#3037462-LU
300 11th Ave E
Recommendation
08 April 2022

300 11th Ave E
SDCI #3037462-LU

The proposed project involves the demolition of 2 existing structures and the construction of a new multifamily structure containing 29 apartment units with a mixture of studios, 1 and 2-bedrooms. No parking proposed.

GUIDANCE RESPONSE STUDIES: MASSING
Studies Requested By Planner

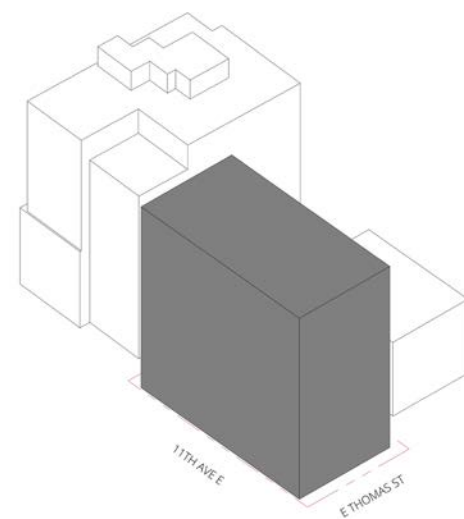
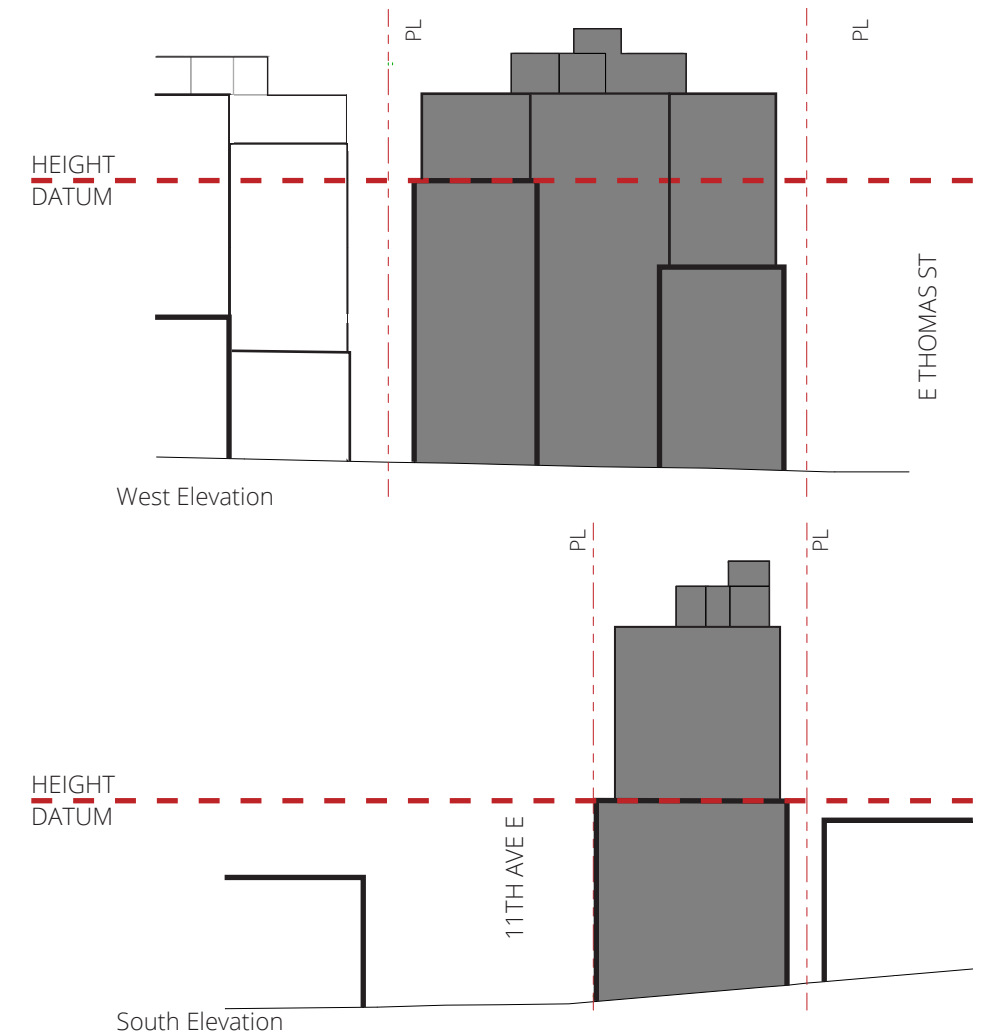
MUP Proposal
MUP Item 3: At MUP, the Land Use Planner supported the massing framing the central courtyard, but recommended further study of the location and proportion of upper-level setbacks.

- The asymmetry in stepping relates to the existing and proposed neighbor massing. If the south leg is raised that connection is lost with the east neighbor. DC2.A.2 Reducing Perceived Mass

- The massing concept is the response to a courtyard building on a corner lot, combining merits of scheme B & C from EDG. A symmetrical massing will ultimately turn its back to one of the street fronts.

- While 11th Ave E has more frontage, E Thomas St carries more of the vehicle and pedestrian flow. The lowered massing at the corner acknowledges that both streets are of equal importance. (CS2.C.1 Corner Sites, CS2.2 Respond To Different Streets (Capitol Hill))

- The symmetrical footprint references the layout of traditional building on Capitol Hill. The symmetry is reinforced for the pedestrian experience through the use of materials, balconies, and fenestration patterns. The asymmetrical massing on the upper levels brings a contemporary design to the building, while material repetitions at the articulations brings cohesiveness to both masses. CS3.1 Fitting Old and New Together (Capitol Hill), CS3.A.4 Evolving Neighborhoods

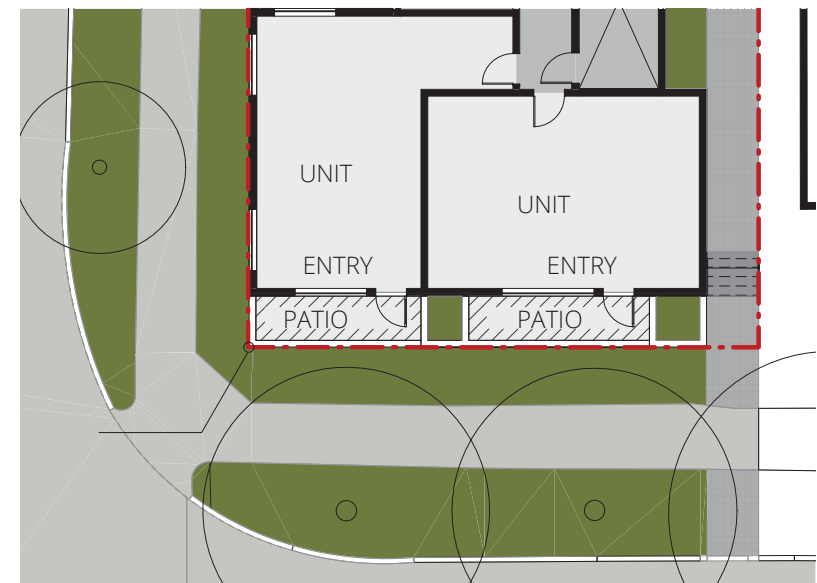
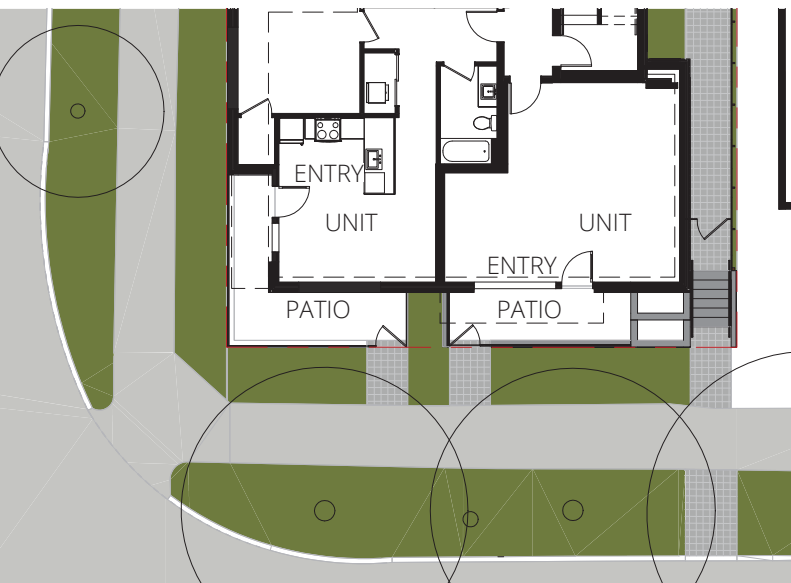
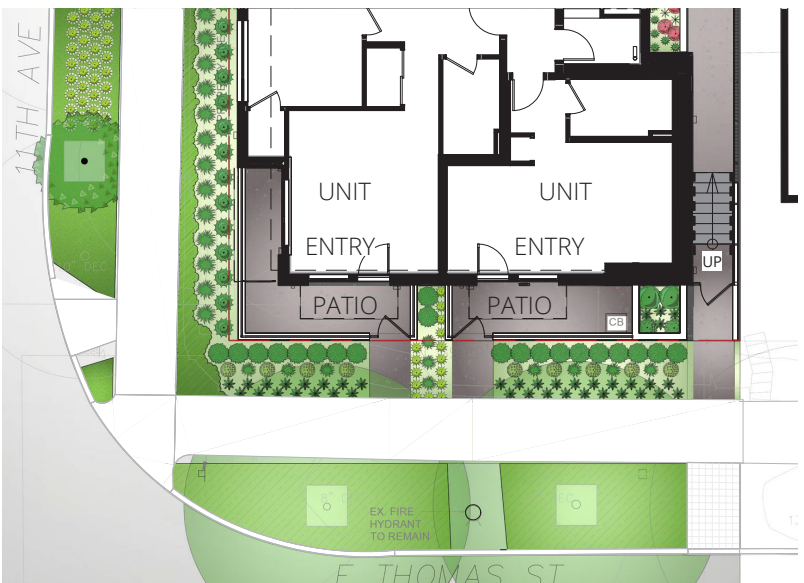
MUP Item 5: The Land Use Planner recommended adjustments to the location of the entries along E Thomas St, canopy locations and heights, and railing heights.

Both E Thomas St unit entries have been relocated and face E Thomas St. Doors have been relocated to provide a clear entry path that maximizes usable patio space. Doors, windows, and canopies create a unified composition. Canopies align with the datum of adjacent balconies. Lighting, drainage, and railing were further refined. PL3-1-c. Ground-Floor Units, DC3-A-1. Interior/Exterior Fit, PL2.B.1 Safety and Security: Eyes on the Street, PL3.2.A, Residential Edges, DC2.4 Scale and Texture (Capitol Hill))

EDG / MUP Proposal and Guidance: 4a 4b 4c

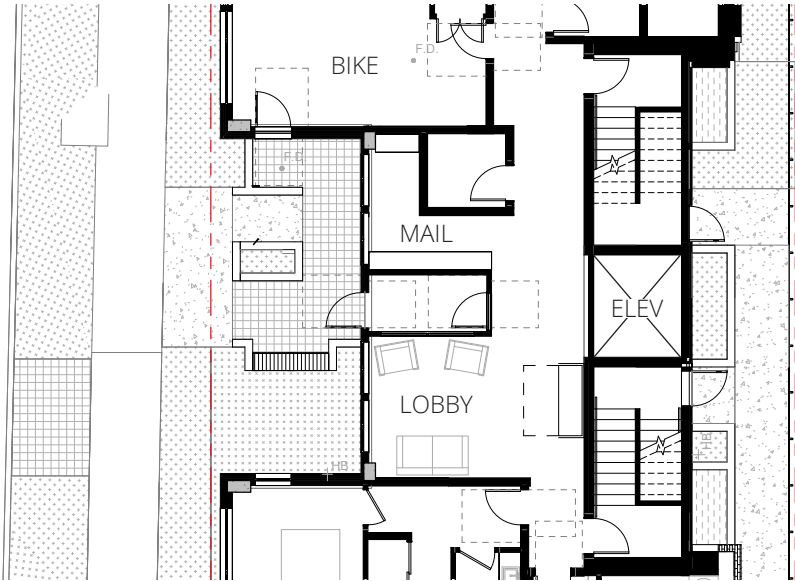
MUP Item 4: At MUP the Land Use Planner thought the courtyard entry sequence needed coordination between site layout, entry door, and interior amenity space. The Planner thought that the angles in the courtyard design have no relationship to the architecture or other site elements. The Planner wanted the entry door to be moved south to provide a centralized, orthogonal entry.

- Pushing the entry door south to be centered in the courtyard divides the lobby into two smaller spaces, further limiting the amount of usable lounge space.
- The orthogonal entry path does not acknowledge the corner lot condition where the prominent site entry approach is the corner of 11th Ave E and E Thomas St.
- When approaching the courtyard from the south the entrance door is not visible until nearly reaching the corner of the courtyard massing. The bike room door is the first visible door on approach, further reducing the prominence of the entry door.
- The grade at the right of way necessitates an accessible ramp north of the entrance door, making a symmetrical courtyard design infeasible.

- The interior layout has been refined to provide a large uninterrupted lobby space for user gathering and overlooks a lush planter strengthening the indoor-outdoor connection
- The angled pathway breaks the orthogonal symmetry of the building providing relief from the rigorous layout and offering contrast for visual interest. This move is repeated in the entrance canopy to add cohesiveness to the design and orients the signage to be visible from both 11th Ave E and the corner of 11th Ave E and E Thomas St
- A secondary pathway was added at the north of the courtyard to provide equal access to pedestrians approaching from the north. Guidelines: PL3.1.B Entries, CS2.C.1 Corner Sites, CS2.2 Respond to Different Streets (Capitol Hill), DC2.3 Scale and Texture (Capitol Hill)

1. SMC 23.45.518.B: North Setback (rear lot line)

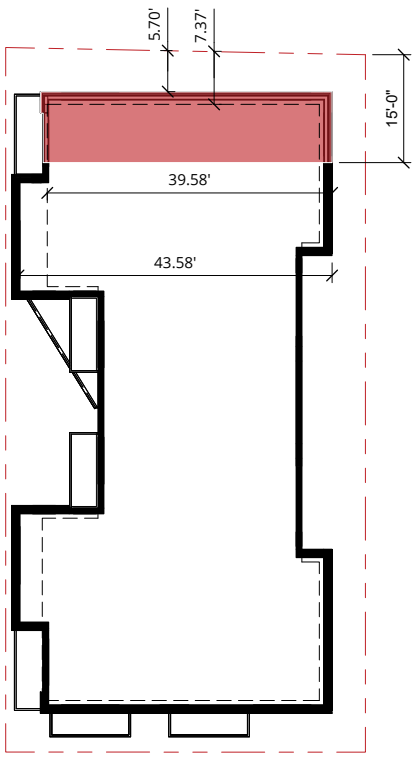
Staff preliminarily supported this departure at EDG

- Departure allows massing to be pushed to the north to strengthen the courtyard concept
- Massing at the north relates to proposed neighboring building in scale and density and allows less mass at east neighbor where building is of a smaller scale and density
- Departure allows massing to build a stronger street fabric
- Departure allows rear setback to read more as a side setback because of the corner lot condition

2. SMC 23.45.518.B: East Setback (side interior lot line below 42 ft)

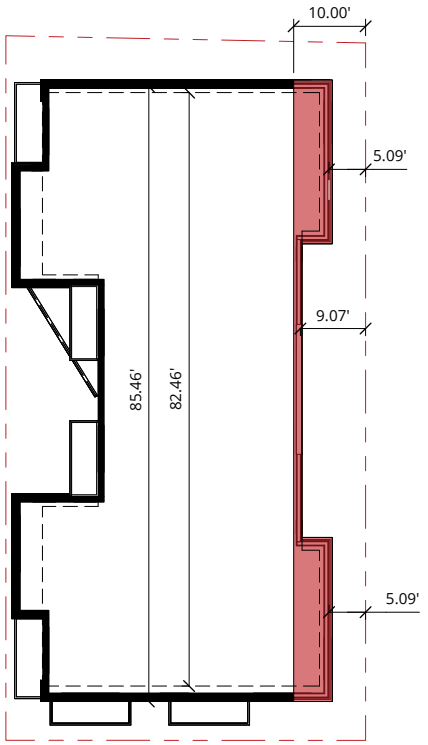
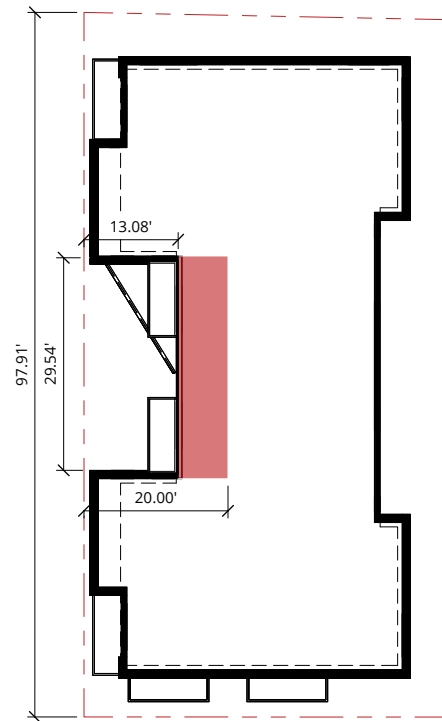
Staff preliminarily supported this departure at EDG

- Massing is redistributed to the east to allow for courtyard massing.
- Departure allows for upper-level stepping to be achieved at the other 3 facades where it supports the courtyard typology.
- Departure provides vertical modulation that gives definition to the building core and "barbell" shape.
